# UNITED STATES PATENT AND TRADEMARK OFFICE

| 10/575,875   | 02/01/2007  | Patrick Lewis Blott  | SMNPH.004APC                    | 6850                        |

## Office Action Summary

### **DETAILED ACTION**

**FIG 1**

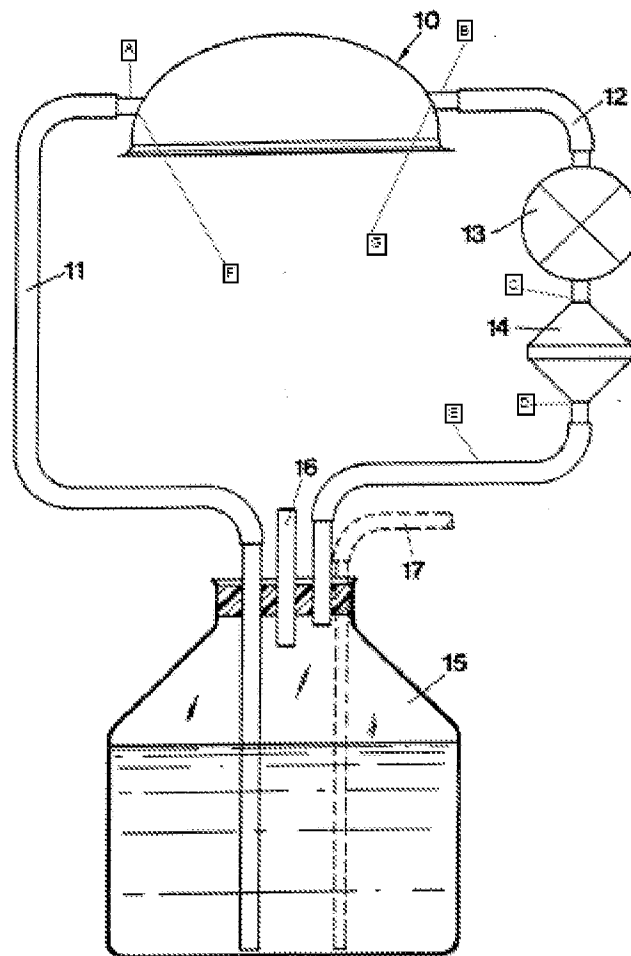
10. In Re claim 19, Swanbeck discloses a device for rinsing and treating wounds comprising: a suction cup 10 (Fig. 1) which is the wound dressing made of rubber or plastic (p. 2, ln. 33) and consequently fully capable of forming a fluid-tight seal or closure over a wound; the feed and discharge tubes (inlet and outlet pipes) A and B (Fig. 1) connected to outlet and discharge tubes 11 and 12 (p. 2, ln. 34, 35; Fig. 1); a sterilizing filter (fluid cleansing means) 14 (p. 3, ln. 33; Fig. 1) having an inlet port C (Fig. 1) connected to a fluid offtake tube 12 (Fig. 1) and an outlet port D (Fig. 1) connected to a fluid recirculation tube E (Fig. 1); a fluid reservoir 15 (Fig. 1); a peristaltic pump 13 (p. 2, ln. 37 – p. 4, ln. 1; Fig. 1) which is a device for moving fluid through the wound dressing and cleansing means; an apparatus for supplying thermal energy (p. 4, ln. 3-5). With regard to the bleeding means, it is the position of the Examiner that fluid is supplied via tube 11 from the reservoir 15 and recirculated through the device via tube 12, recirculating the fluid through the flow path.

providing a conformable wound dressing 10 (Fig. 1) configured to form a relatively fluid-tight seal around at least a portion of a wound (p. 2, ln. 33);

the feed and discharge tubes (inlet and outlet pipes) A and B (Fig. 1) connected to outlet and discharge tubes 11 and 12 (p. 2, ln. 34, 35; Fig. 1);

pumping fluid through at least the inlet pipe, the wound dressing, and the outlet pipe (p. 2, ln. 37 – p. 4, ln. 1; Fig. 1);

cleansing the fluid that flows out of the wound dressing (p. 3, ln. 33; Fig. 1);

19. In Re claim 1, Swanbeck discloses a device for rinsing and treating wounds comprising: a suction cup 10 (Fig. 1) which is the wound dressing made of rubber or plastic (p. 2, ln. 33) and consequently fully capable of forming a fluid-tight seal or closure over a wound; the feed and discharge tubes (inlet and outlet pipes) A and B (Fig. 1) connected to outlet and discharge tubes 11 and 12 (p. 2, ln. 34, 35; Fig. 1); a sterilizing filter (fluid cleansing means) 14 (p. 3, ln.

33; Fig. 1) having an inlet port C (Fig. 1) connected to a fluid offtake tube 12 (Fig. 1) and an outlet port D (Fig. 1) connected to a fluid recirculation tube E (Fig. 1); a fluid reservoir 15 (Fig. 1); a peristaltic pump 13 (p. 2, ln. 37 – p. 4, ln. 1; Fig. 1) which is a device for moving fluid through the wound dressing and cleansing means; an apparatus for supplying thermal energy (p. 4, ln. 3-5). With regard to the bleeding means, it is the position of the Examiner that fluid is supplied via tube 11 from the reservoir 15 and recirculated through the device via tube 12, recirculating the fluid through the flow path.

23. In Re claim 5, Swanbeck discloses the apparatus comprising a sterilizing filter 14 (p. 3, ln. 33; Fig. 1) which is an equivalent of a single-phase cleansing system.
